Flue

Main Floor Fireplace

Level 1 Open Wood Fireplace/Chimney Inspection- \$209

- **Flue tile sealed at smoke chamber:** Does not meet industry standards

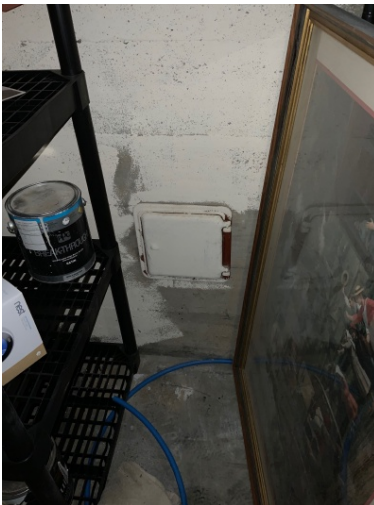
The flue tile is not sealed at the top of the smoke chamber. This can allow the byproducts of combustion to go behind the flue tiles and may migrate to areas of the chimney and home not meant to contain them. The

Behind the tile tiles and may migrate to areas of the chimney and home not meant to contain them. The potential hazard exists that combustible residue could build up where it cannot be maintained and allow the possibility of a structure fire. This defect could also allow carbon monoxide to enter the home. 2016 NFPA 211 11.2.1.13

- **Fireplace width: 36**
32 rear
- **Clearance to combustible trim: 7**
5" sides
- **Ash pit clean out door (condition and clearance to combustibles): Potential hazard**

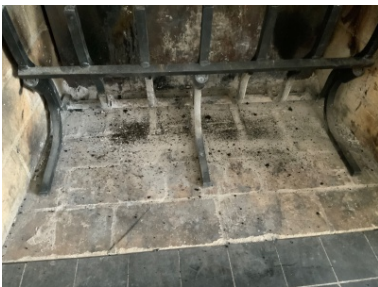
There are combustible materials that are too close to the ash cleanout door. This could potentially be a fire hazard. The Clearance to combustibles is to be 18" 2016 NFPA 211 7.1.4.5 IRC 2006

• **General condition of the firebox: Deteriorated**

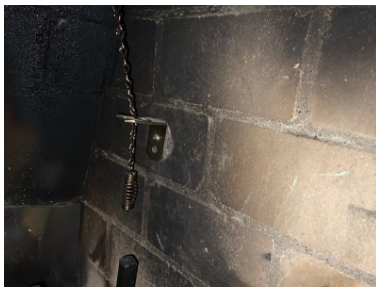
The firebox has deteriorated mortar joints. Firebrick are to be laid with a medium-duty refractory mortar. The width of the joints in the firebox should not exceed 1/4". 2016 NFPA 211 11.2.1.4 IRC 2006 2111.5
